# **Final Report of Special Inspections**

## **Martin's Point Health Care Medical Office Building**

August 13, 2010

**Project No. 09012**

ONE-BEAM - 97B1P

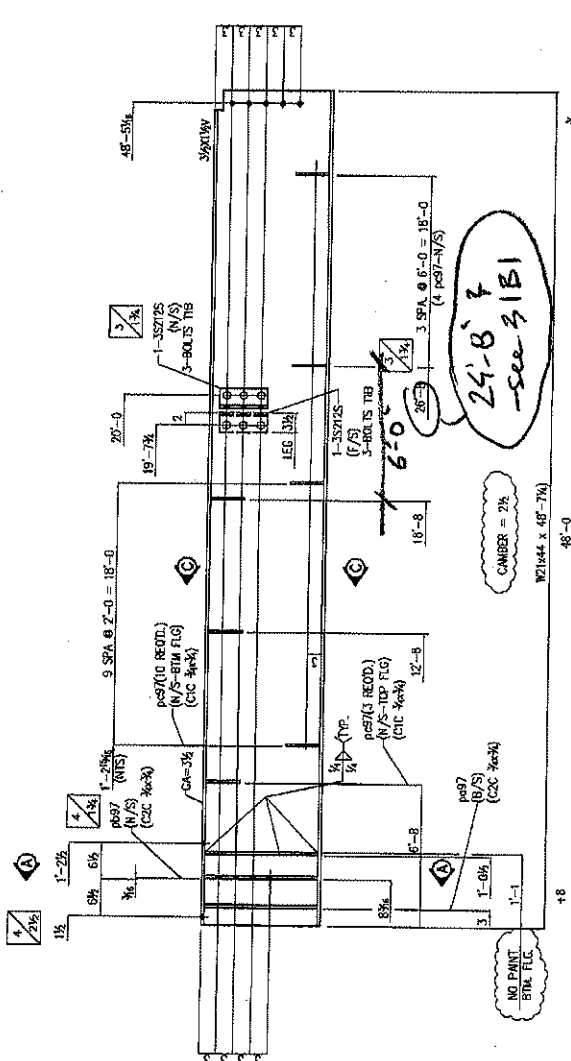
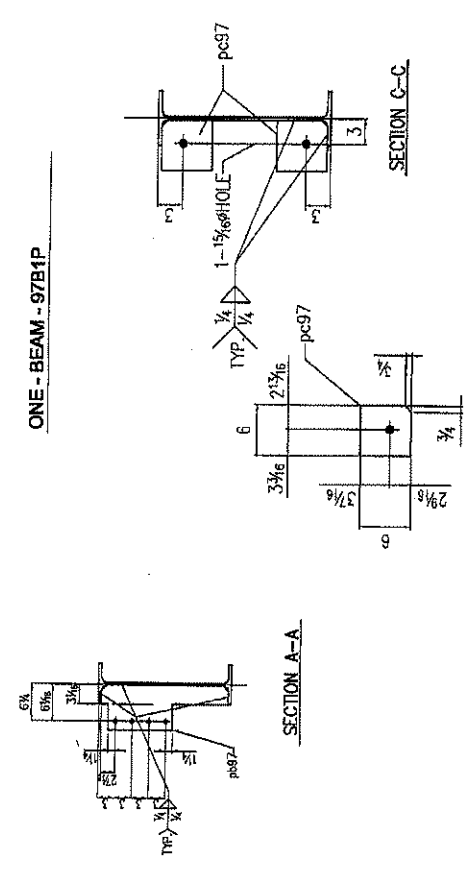
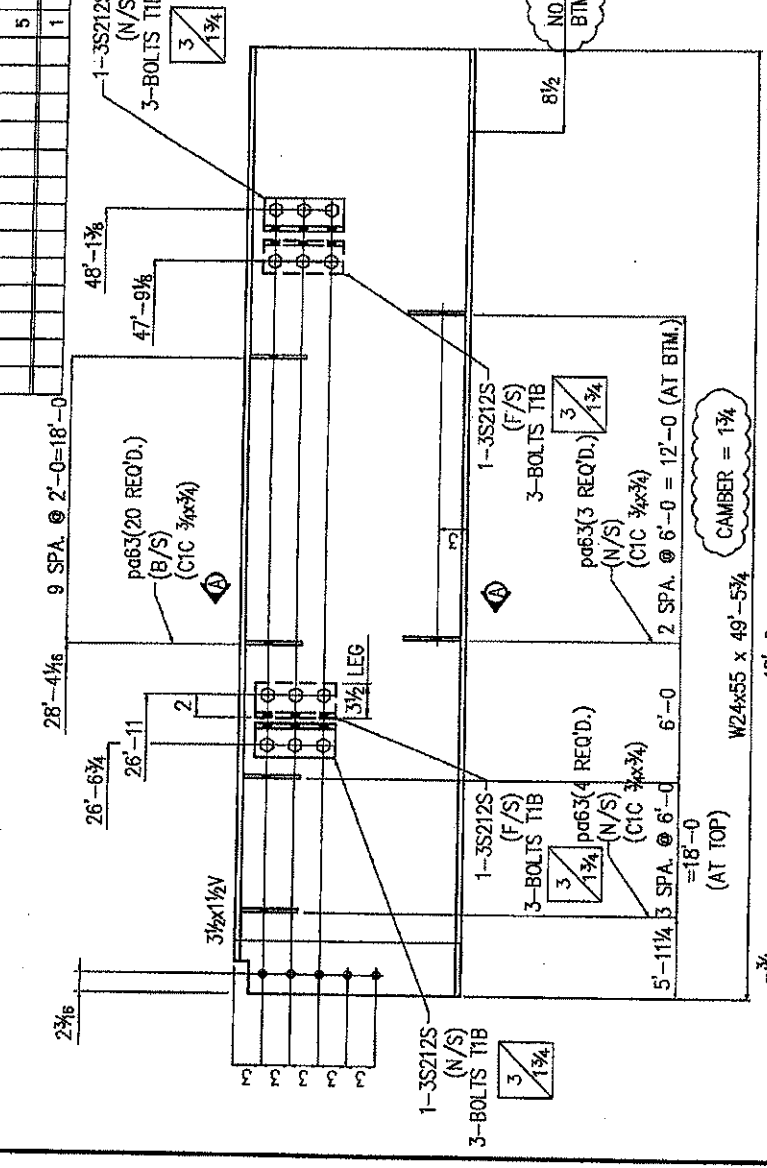
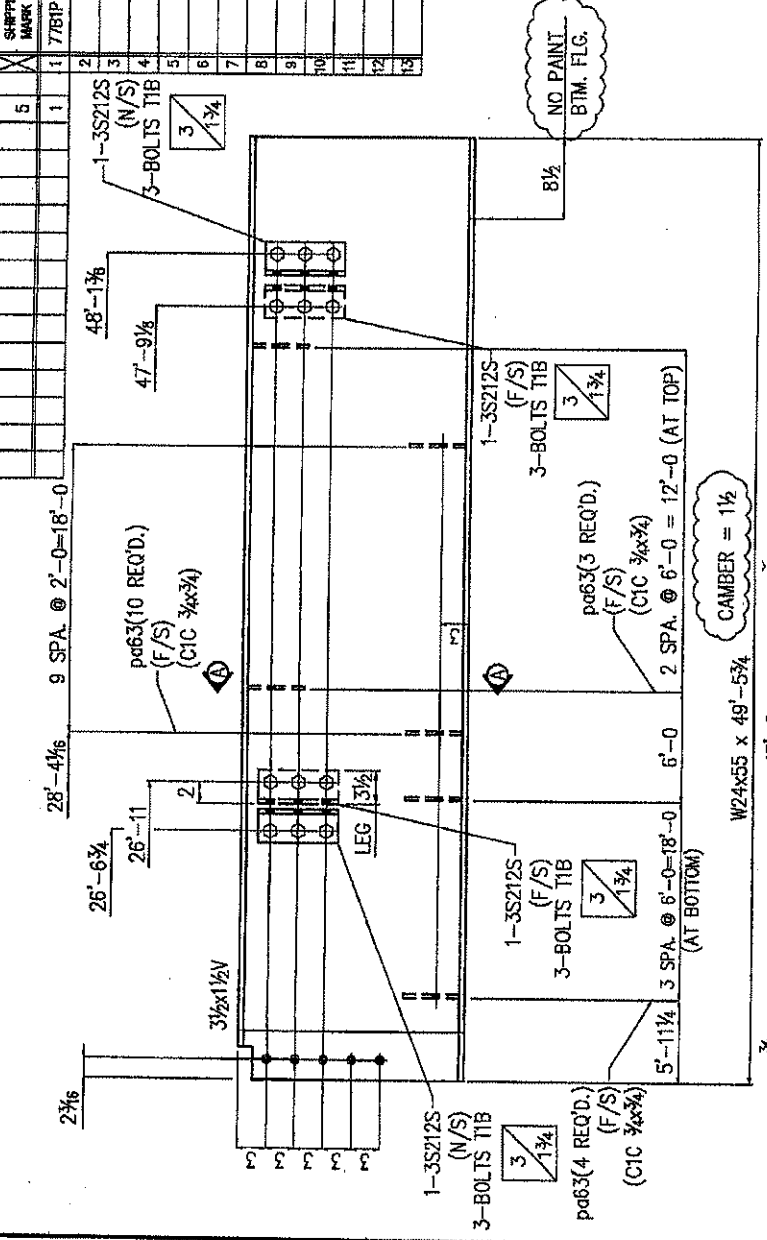
The angle brace directions were modified during the steel shop drawings review. The correct angle directions are defined by the connection plate locations as shown on the shop drawings #31 and #97, SMRT submittal #68 (copies of the drawings are attached for reference).

Please note that angle brace directions were also revised at the floor beams located next to the stair shaft next to line D. The correct connection plate locations are shown on beams 76B1 and 77B1 (SMRT submittal #68, shop drawings #76 and #77 - copies attached)

PARTIAL FRAMING LEVEL 3  
REF E2

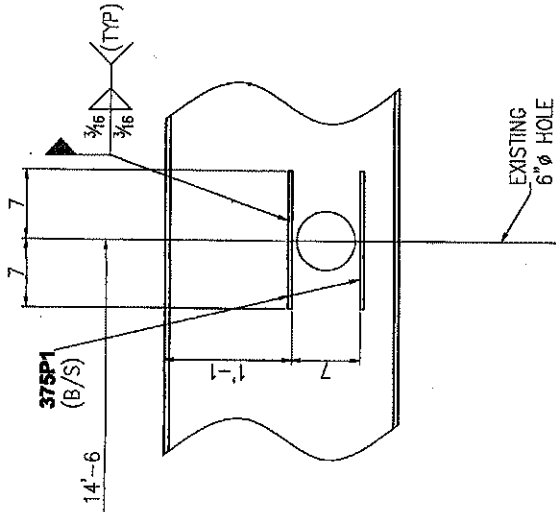
1. Missing web stiffeners at beam web penetration. The penetration located at the centerline of beam 87B1 did not contain stiffeners in accordance with detail A15/SF102. See Photo MPH C MOB 37 attached.
2. The bottom flange of beam 23B1 was field cut to allow for the installation of the bolted connection of the beam on the opposite site of the girder. See photo MPH C MOB 38 attached.

CORRECTIVE WORK  
ADD REINFORCING  
RS AT MIDDLE  
WEB PEN

KPHC - ROOF DECK REPAIR LAYOUT

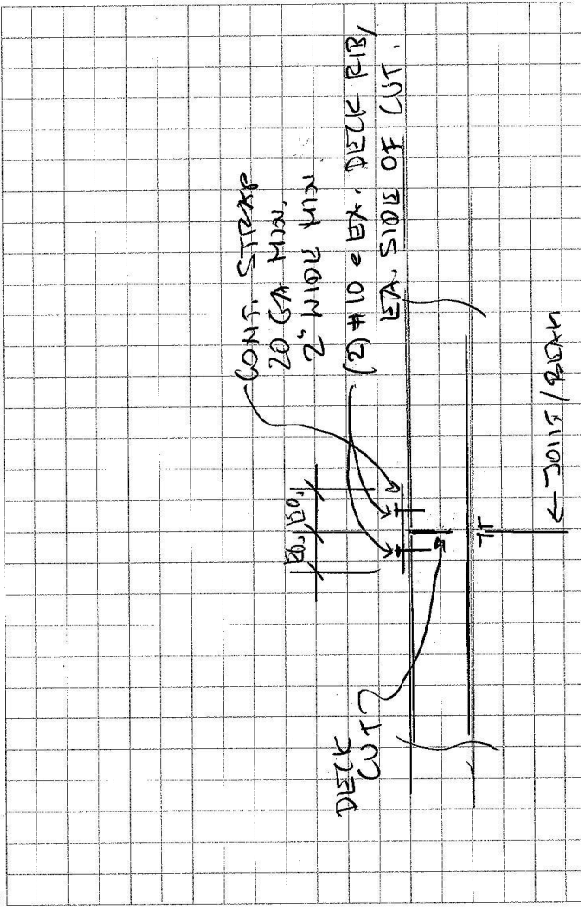
At a number of areas the top flutes of the deck were cut in order to slope the deck to match the structure thus causing the deck to span fewer than three spans. These area are shown in the drawings attached to Field Report 5-006. EOR should review conditions to verify as built conditions are acceptable or offer remedial fix.

1. Refer to attached SMRT sketches S-1, S-2 and S-3 (NC-006-response.pdf) for the required deck repair detail and locations.  
Re-inspection by Special Inspector is required.
2. Contractor shall submit for SMRT review the locations of deck cuts at the roof areas already covered with roofing. If required, the deck repair which can be installed at the bottom of the deck will be provided.
